Evaluation of the Environmental Protection Agency Treatment of Life Cycle Assessment in the Renewable Fuel Standard Rulemaking

Stefan Unnasch, Brent Riffel, Larry Waterland, Life Cycle Associates
Christopher Loreti, The Loreti Group

American Petroleum Institute
1220 I Street, NW
Washington, DC 20005

Figure 2.6. Incremental revisions to corn ethanol fuel cycle greenhouse gas emissions

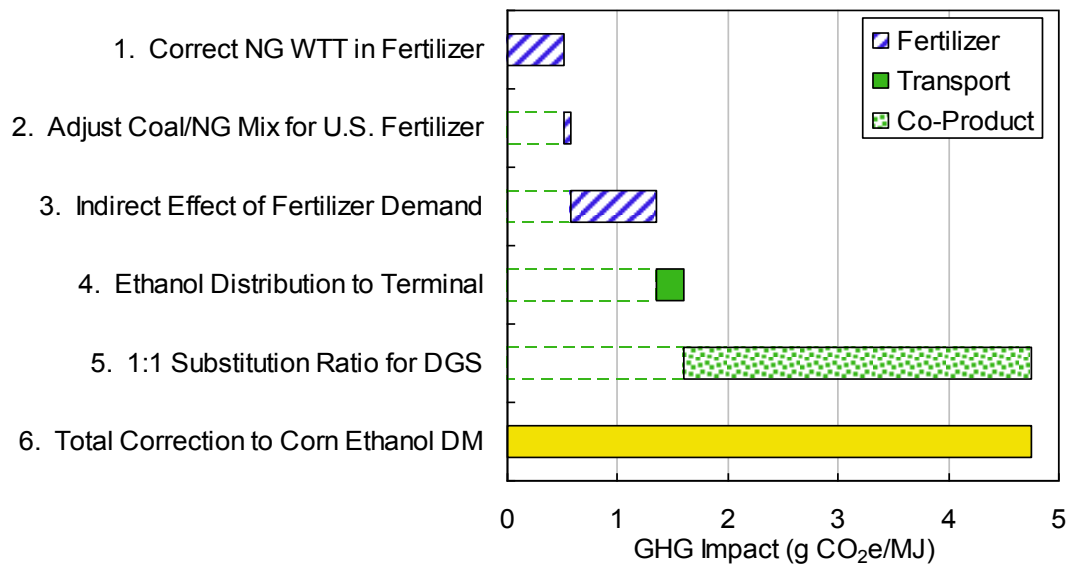
DGS co-product credit using the input assumptions ARB used in developing the California LCFS. Case 6 sums the GHG emission increments for Cases 1-5, and represents the sensitivity of corn ethanol WTT emissions to GREET input assumptions. Figure 2.6 below shows the incremental emissions graphically. A summary of the six cases show in the figure is as follows:

1. Correct the GREET ammonia emission calculations to include the upstream emissions associated with producing the NG used (0.51 g CO₂e/MJ increase)
2. Adjust the feedstock mix for dry urea fertilizer used in the U.S. to 6.7% coal/93.3% NG from the default 100% NG (0.07 g CO₂e/MJ increase)

The net impact of correcting the ammonia error (Case 1) and applying the correct coal-weighted urea mix (Case 2) is a 0.6 g CO₂e/MJ GHG emissions increase, a modest but important revision because many biofuel pathways rely on fertilizer inputs. The conservative preliminary estimate for the indirect fertilizer increment (Case 3) is 0.8 g CO₂e/MJ. The additional corn ethanol distribution distance (Case 4) has a small impact on WTT emissions (0.2 g CO₂e/MJ). However, applying the California LCFS DGS co-product inputs (Case 5) significantly increases (3.2 g CO₂e/MJ) corn ethanol WTT emissions. The DGS credit is larger in the default GREET methodology than in the California LCFS methodology due to different co-product displacement factors. GREET assumes that DGS displaces corn on a one-to-one mass basis, in addition to displacing soy bean meal and nitrogen in urea, whereas the ARB LCFS method assumes only one-to-one feed corn displacement on a mass basis.

Figure 2.7. Incremental revisions to sugar cane ethanol fuel cycle greenhouse gas emissions

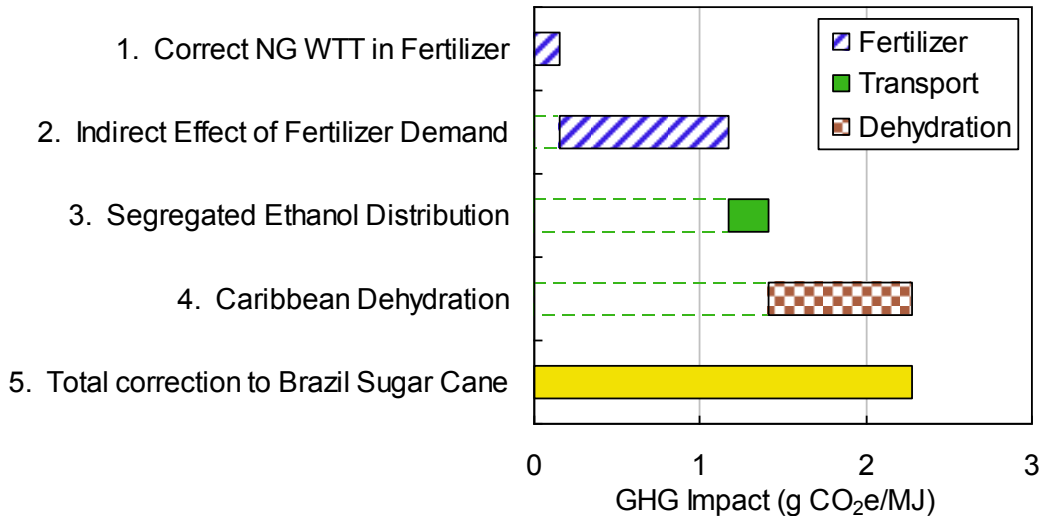
Sensitivity calculations were performed for the Brazilian sugar cane ethanol pathway in GREET for three of the revisions discussed above and a Caribbean dehydration scenario. The emission changes shown below in Figure 2.7 are relative to the default GREET WTT sugar cane ethanol result (26.6 g CO₂e/MJ). Although Brazilian fertilizer data are difficult to locate, the nitrogen fertilizer mix is assumed to be 100% NG (the GREET default), due to the availability of cheap South American NG sources in Argentina, Chile, Peru, etc. Therefore, an emission increment for coal-weighted ammonia production was not calculated for fertilizer used in Brazil. Scenario 4 in the figure shows the net impact of using heavy fuel oil to dehydrate Brazilian ethanol to anhydrous ethanol in the Caribbean rather than using bagasse-based heat in Brazil (Macedo and Seabra 2008). Caribbean dehydration plants process more than one third (37%) of the Brazilian ethanol production to anhydrous ethanol. Ethanol dehydrated in the Caribbean becomes classified as a Caribbean fuel, thereby avoiding the U.S. tariff applied to Brazilian ethanol. The full emission increment for ethanol dehydrated with residual oil in the Caribbean compared to ethanol dehydrated with bagasse in Brazil is 2.3 g CO₂e/MJ. Incremental case descriptions and results are listed below. A summary of the six cases shown in the figure is as follows:

1. Correct the GREET ammonia emission calculations to include the upstream emissions associated with producing the NG used (0.15 g CO₂e/MJ increase)
2. Estimate the indirect effect of fertilizer demand by considering that new international N fertilizer production capacity is coal-based. Estimate indirect fertilizer value as the difference between 80% coal/20% NG and 100% NG-derived ammonia (1.02 g CO₂e/MJ increase)

3. Include additional 30 miles of ethanol transport from bulk terminal to petroleum blending facility that is omitted in GREET (0.24 g CO₂e/MJ increase)
4. Include the emissions for dehydration of 37% of Brazilian ethanol in the Caribbean using residual oil (1,900 Btu/gal) (0.86 g CO₂e/MJ increase)
5. The net impact of all these revisions change Brazilian sugarcane ethanol WTT by 2.3 g CO₂e/MJ

The net impact for the ammonia correction and coal-weighted urea inputs is a 0.3 g CO₂e/MJ increase, and the estimate for indirect effects of urea demand is a 0.9 g CO₂e/MJ increase. As described above for corn ethanol, the indirect emission estimate reflects the difference between the current NG predominant urea and future coal-predominant urea capacity (note that this is an indirect demand effect, not to be confused with an indirect land use change effect). In addition, as Figure 2.7 shows, ethanol dehydrated with residual oil results in significantly higher greenhouse gas emissions than ethanol dehydrated with bagasse (0.9 g CO₂e/MJ increase). The net impact of the life cycle revisions considered here are 2.3 g CO₂e/MJ.

Figure 2.8. Projected U.S. corn farming energy (Source GREET and DRIA⁷)

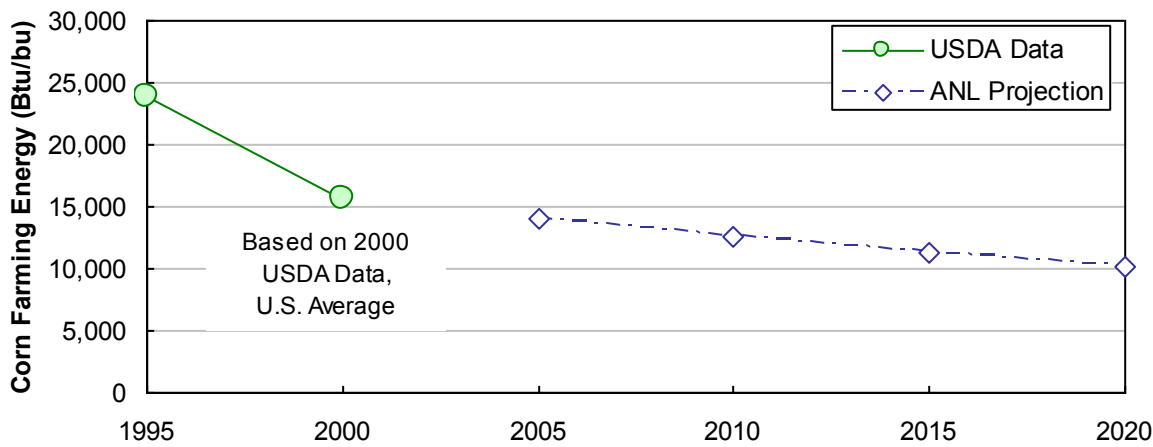
The performance of all parameters is generally projected to improve over time. An example, corn farming energy, is shown in Figure 2.8 (from GREET). The energy used for farming the corn in 2005 (14,000 Btu/bu) represents the equivalent of about 7 g/MJ of GHG emissions. Projections for future improvements would result in the equivalent of about a 2 g/MJ reduction in GHG emissions by 2020. Similarly, process heat requirements, corn yield, and other parameters are also projected to improve. EPA could identify the g/MJ intensity and assumptions corresponding to each tranche of fuels that are rated. Note that the FASOM energy inputs calculated from the charts in the DRIA are consistent with the projections in GREET. The basis for these projections should be documented.

Figure 3.2. Emissions from tar sands production compared to emissions estimated in GREET

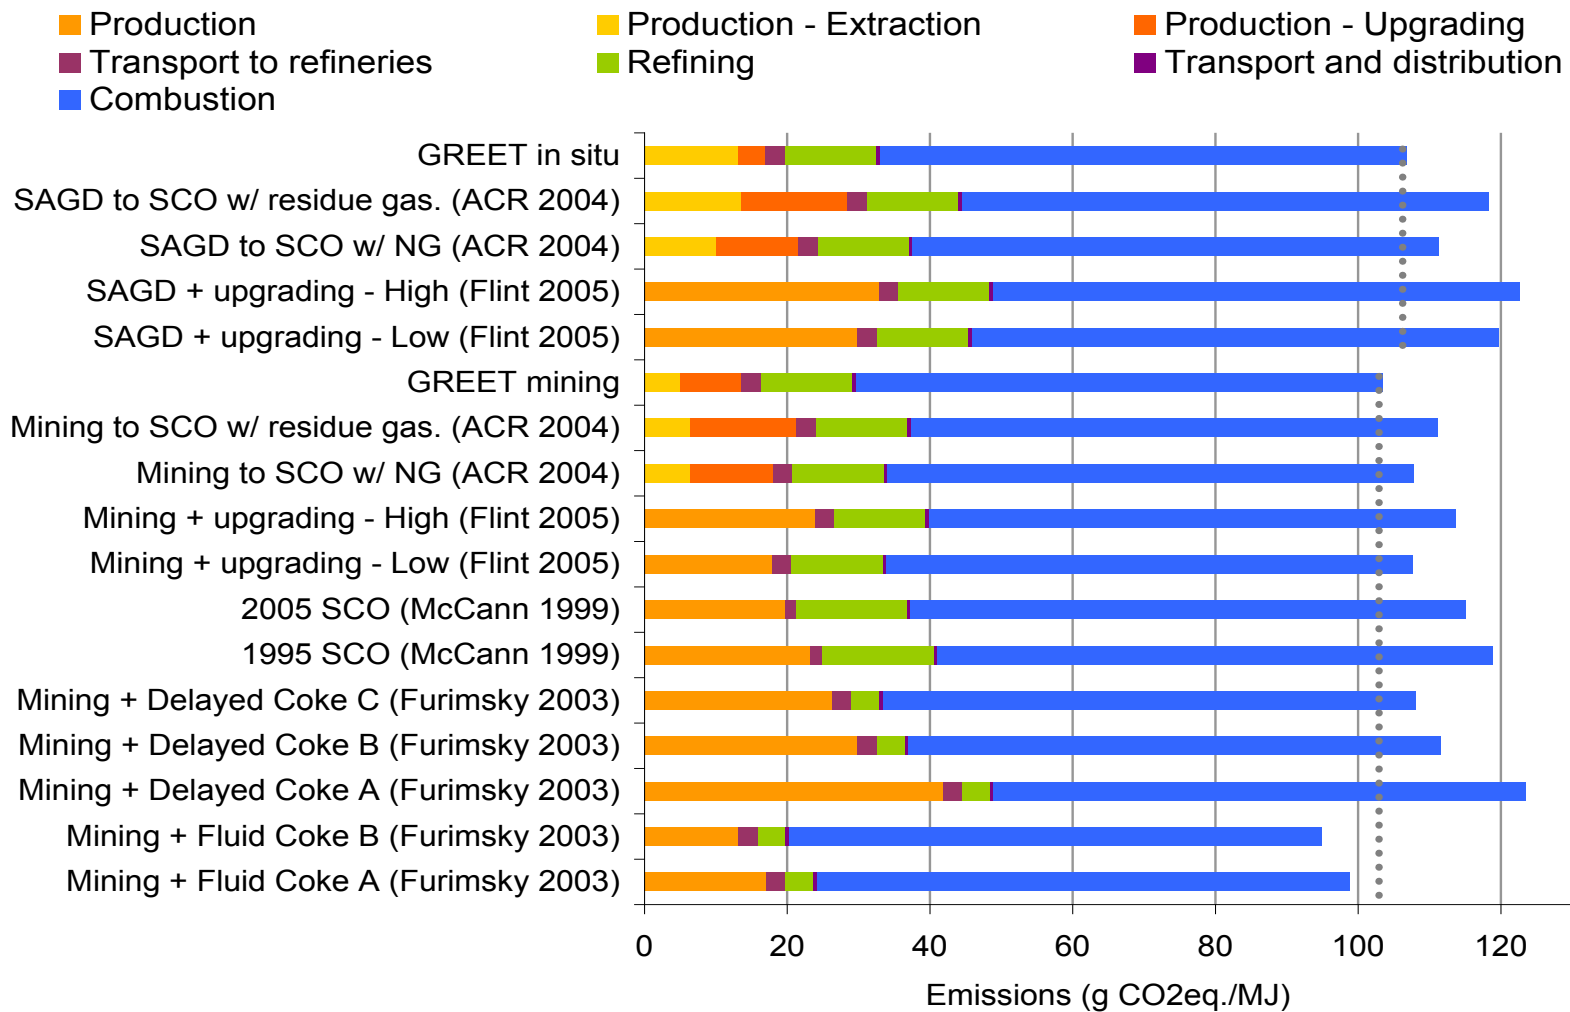
A number of LCAs of tar sands production have been performed, although none are comprehensive across all production stages (Suncor 2003; Bergerson and Keith 2006).¹² Fuel cycle emission estimates from several studies are compared in Figure 3.2. One study from the Alberta Chamber of Resources (hereafter ACR), called the *Oil Sands Technology Roadmap* (OSTR), should be noted because it is the source for GREET energy inputs to tar sands production (Larson, et al. 2004). Results from the OSTR study are shown in results 10-11 (row in the figure counting from the bottom) and 15-16 in Figure 3.2.

Natural gas consumption for in-situ production is about 1,000 MJ/bbl, while electricity consumption is approximately 30 MJ/bbl (8.25 kWh) (ACR 2004). These values are used by GREET, and no other breakdown of energy inputs to in-situ production was found with which to compare these values. GREET assumes that current in-situ production is not upgraded, although other estimates presented above in Figure 3.2 do assume that it is upgraded.
